NP-12-0024
June 11, 2012

Subject: Exelon Nuclear Texas Holdings, LLC
Victoria County Station
Early Site Permit Application
Environmental Report – Response to ER RAI Letter No.8
Docket No. 52-042

References: (1) USNRC letter to Ms. Marilyn C. Kray, Environmental Request for Additional Information Letter No.8 Related to Aquatic and Terrestrial Ecology for Victoria County Station Early Site Permit Application, dated April 27, 2012

Figure 1. VCS Site Potential Wetland Impacts

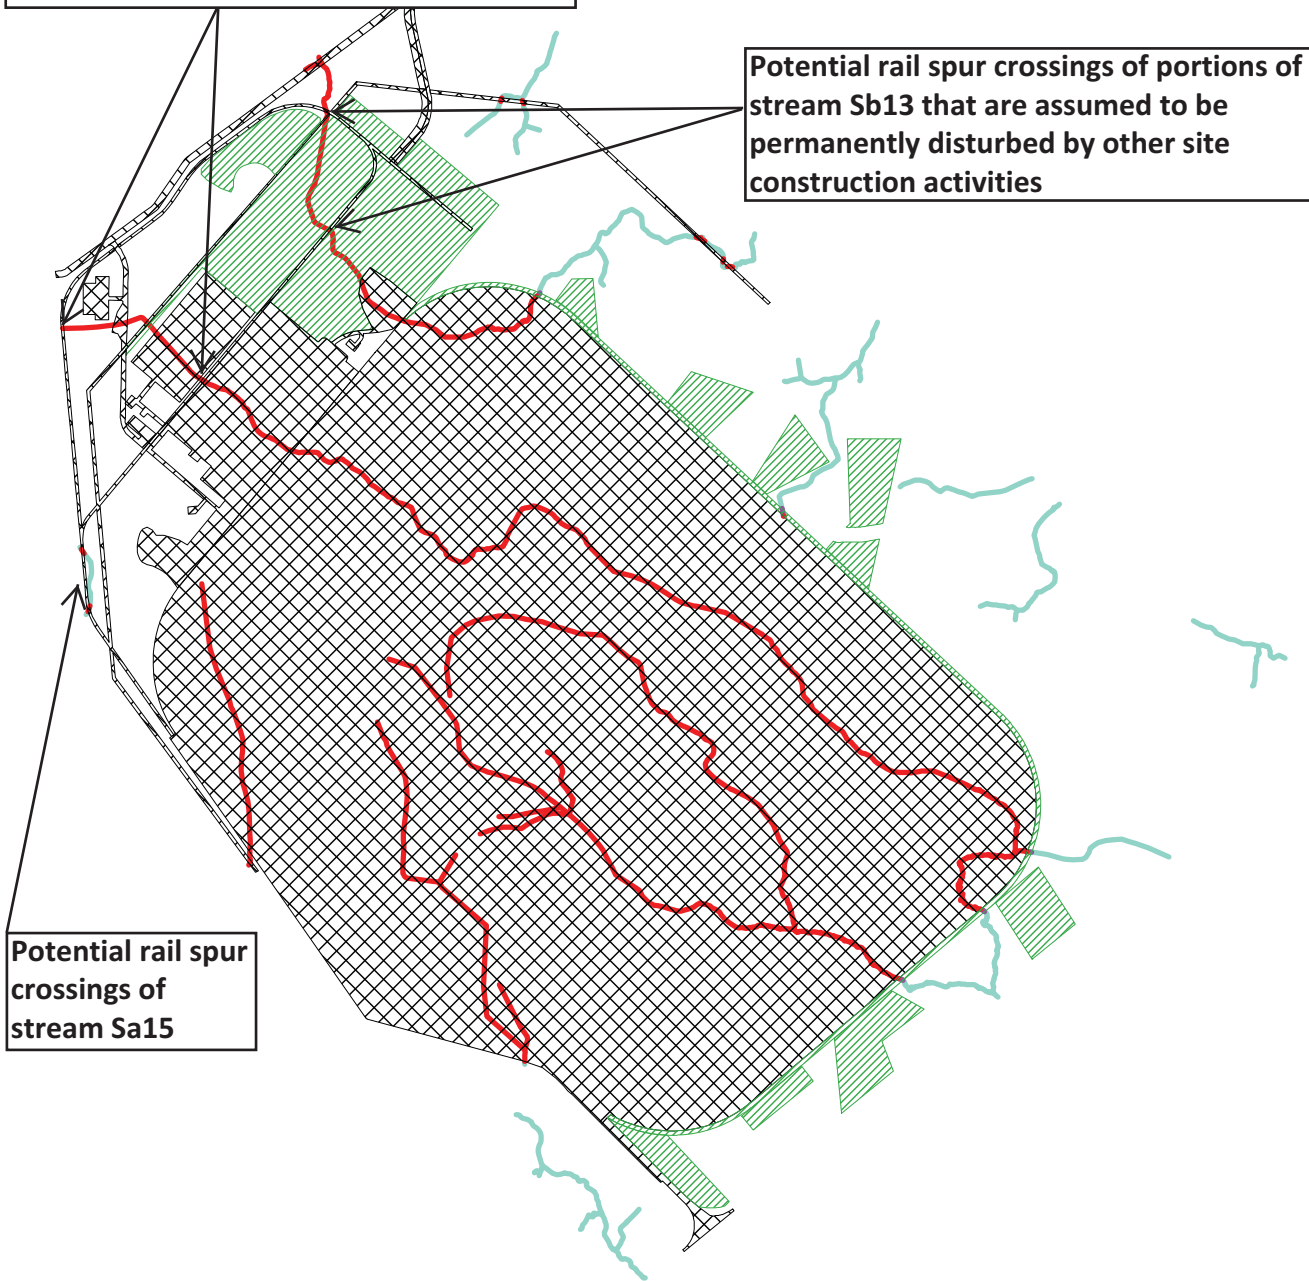
(b) ESRP Section 4.3.2 directs the staff to include an assessment of both onsite and offsite construction activities, including access corridor construction. The proposed rail spur connection crosses a number of streams and wetlands. Information is needed that describes the construction of this rail spur in more detail, particularly as it relates to construction over streams and wetlands and mitigative measures that would be taken to minimize construction impacts. Describe the aquatic and wetland impacts from constructing the rail spur connection and any mitigative measures associated with its construction.

The proposed rail spur is described in ER Subsection 3.9.1.3. Figure 1 and Figure 2 identify the wetland and linear water feature areas, respectively, that could potentially be affected by VCS construction. From these figures, it can be seen that the potential permanent rail spur disturbance of wetlands and streams not anticipated to be impacted by other site construction activities is limited to two portions of wetland Wb1 and two sections of stream Sa15. Locations and descriptions of wetland Wb1 and Sa15 can be found in the VCS wetland delineation report (Tetra Tech 2010), which was submitted via Exelon letter NP-12-0006, dated February 15, 2012 (ML12079A233). No additional temporary or permanent disturbance would be expected from rail spur construction. The acreages and linear feet of potential wetland and water feature impacts associated with rail spur construction are included in the total values presented in Table 1 of Exelon's response to RAI TE-5.

Potential rail spur crossings of portions of stream Sb1 that are assumed to be permanently disturbed by other site construction activities

Potential rail spur crossings of portions of stream Sb13 that are assumed to be permanently disturbed by other site construction activities

Potential rail spur crossings of stream Sa15

**Figure 2.4.1-9 Existing Streams and Wetlands**

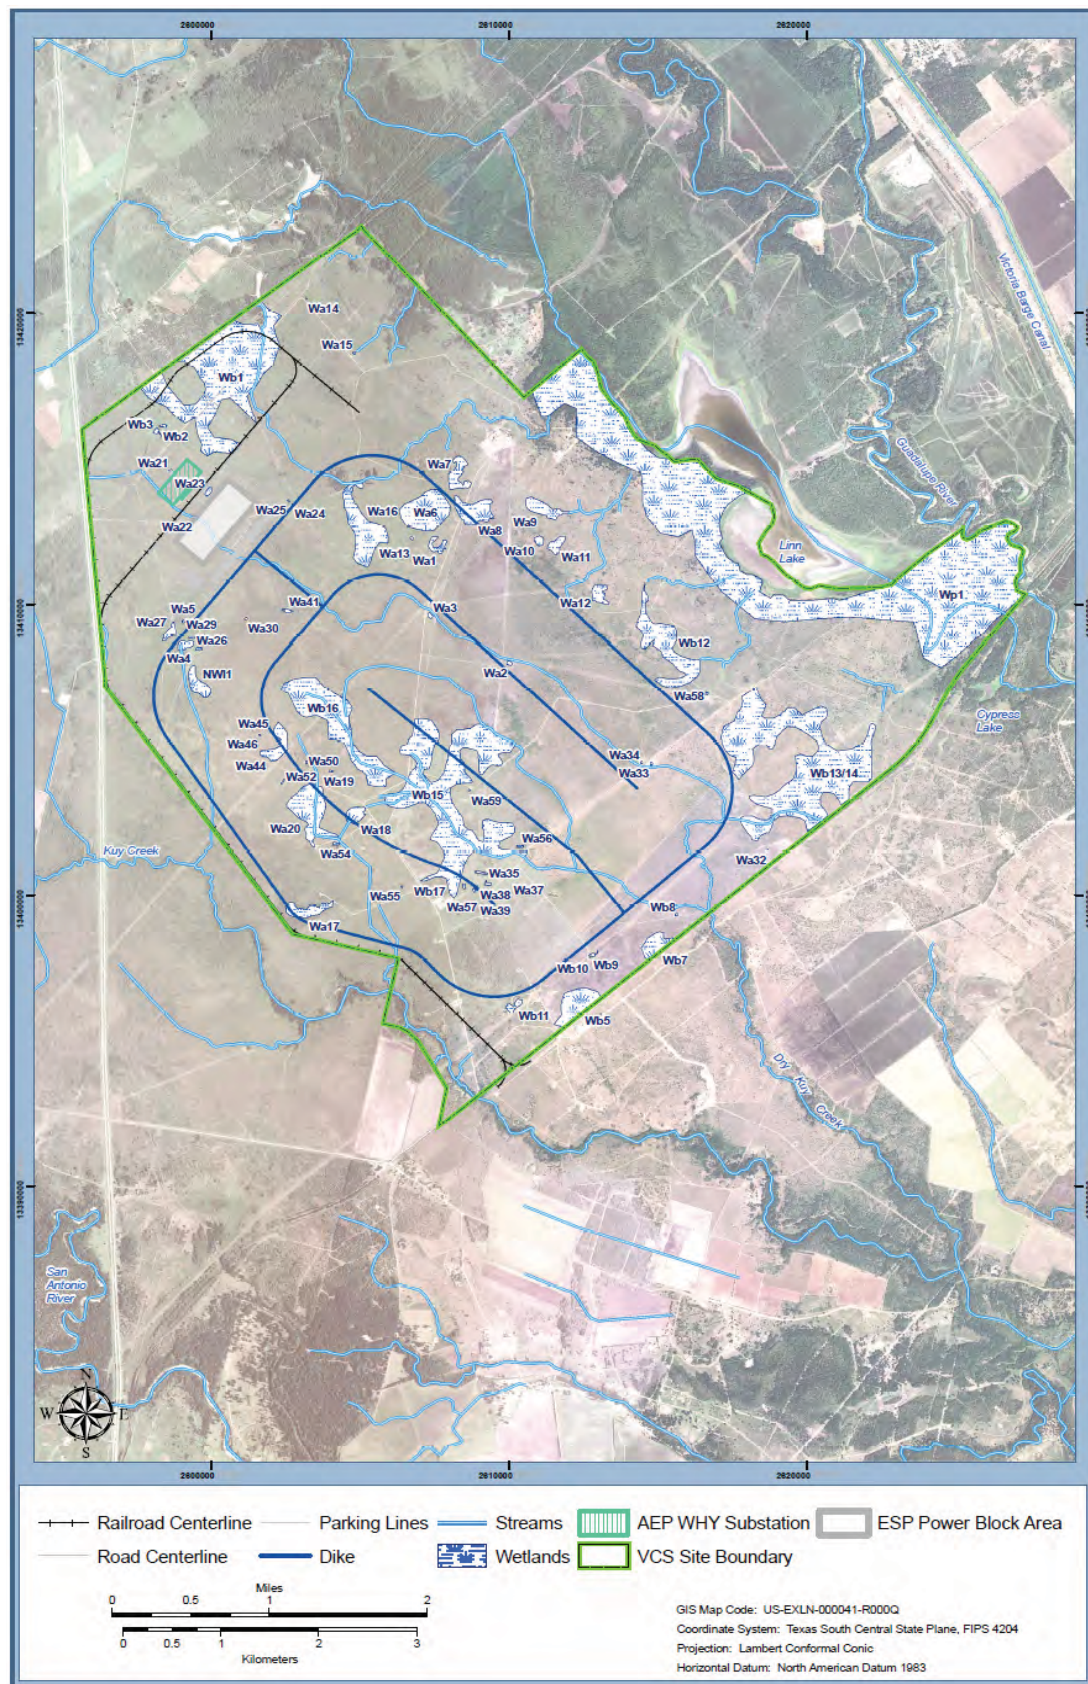
Changes to the following ESPA sections, tables, and figures will be incorporated in a future revision of the ESPA to reflect: 1) the addition of two wetlands identified during USACE PJD activities; 2) the revised construction disturbance footprint; and 3) updated potential wetland impact acreages:

SSAR Figure 2.4.1-9 will be revised as follows:

Figure 4.1-1 Construction Area of Disturbance

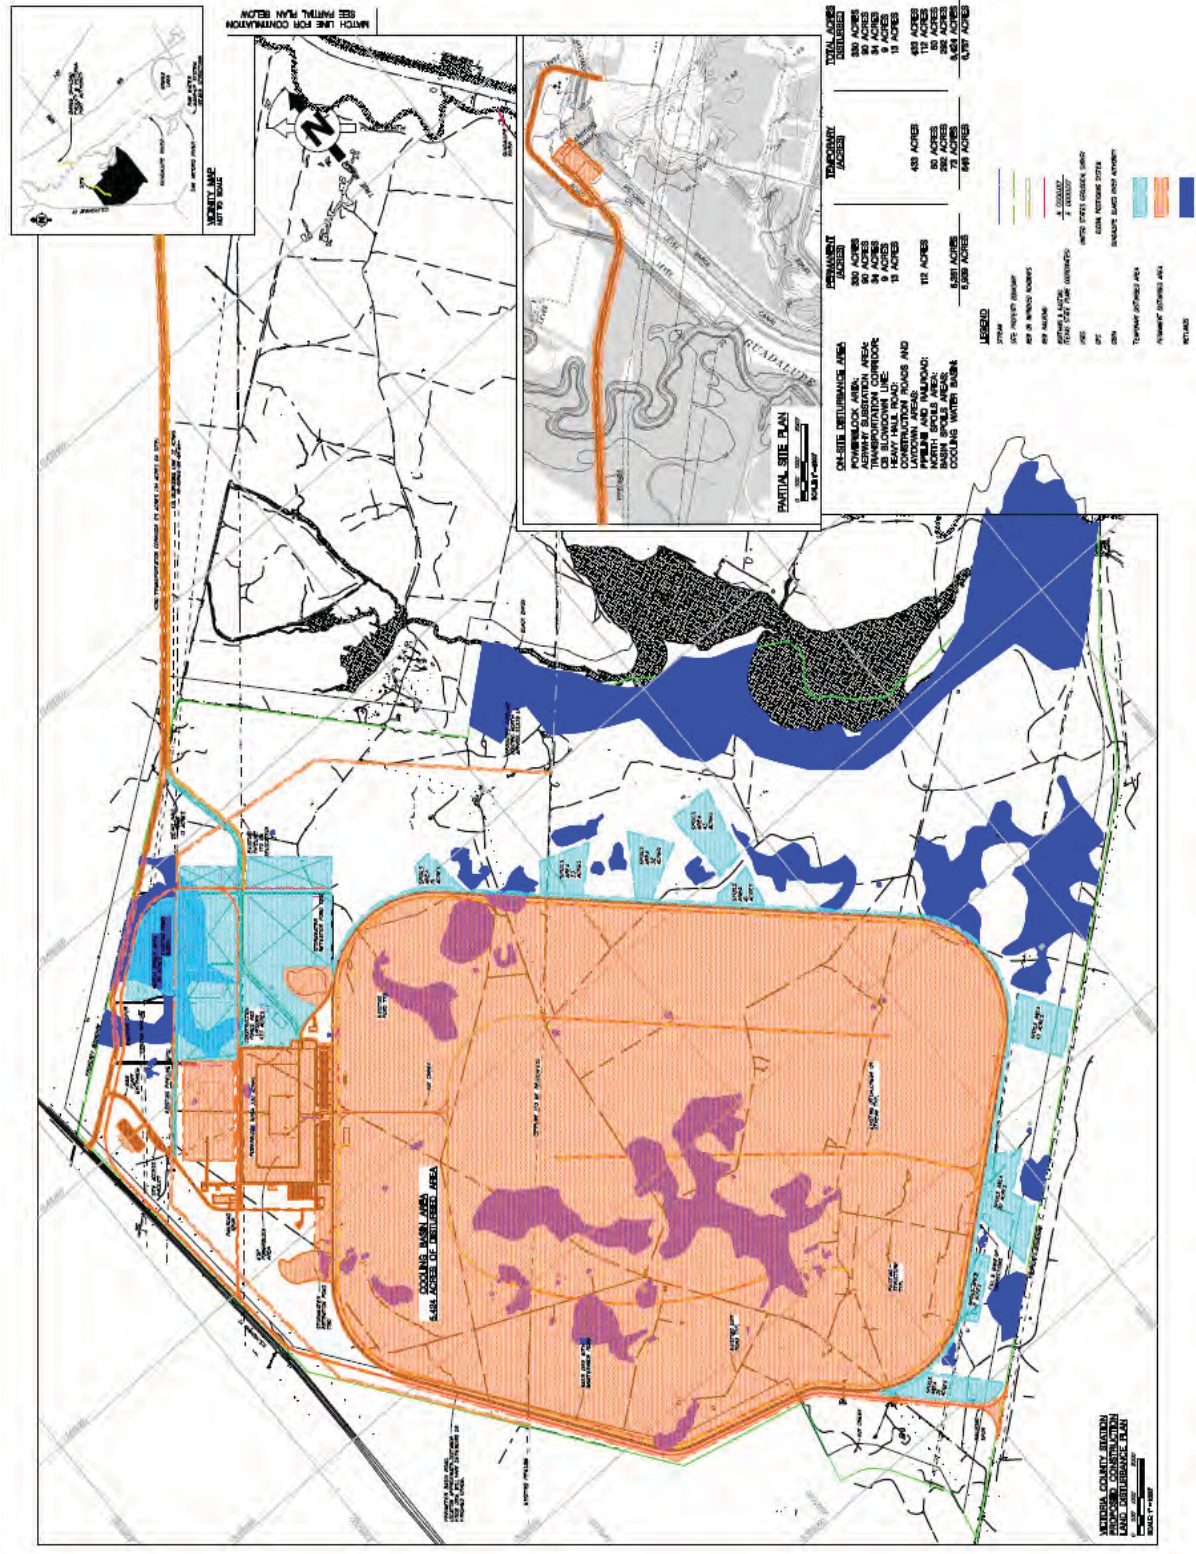
Prior to summarizing the potential temporary and permanent wetland and water feature impacts associated with VCS construction, Exelon updated ER Figure 4.1-1 to reflect revised limits of construction disturbance. Primarily, the soil stockpile areas depicted to the south and east of the cooling basin were broken into smaller areas and relocated to avoid direct wetland impacts to the extent practicable. Revised ER Figure 4.1-1 is provided in the Associated ESPA Revisions section of the response, as is revised ER Table 4.1-1 presenting the updated construction disturbance acreages.

Figure 4.1-1 will be updated, as follows:

Exelon confirms that there would be no project encroachment on Linn Lake. The construction area of disturbance is presented on revised ER Figure 4.1-1, provided in response to RAI TE-5.
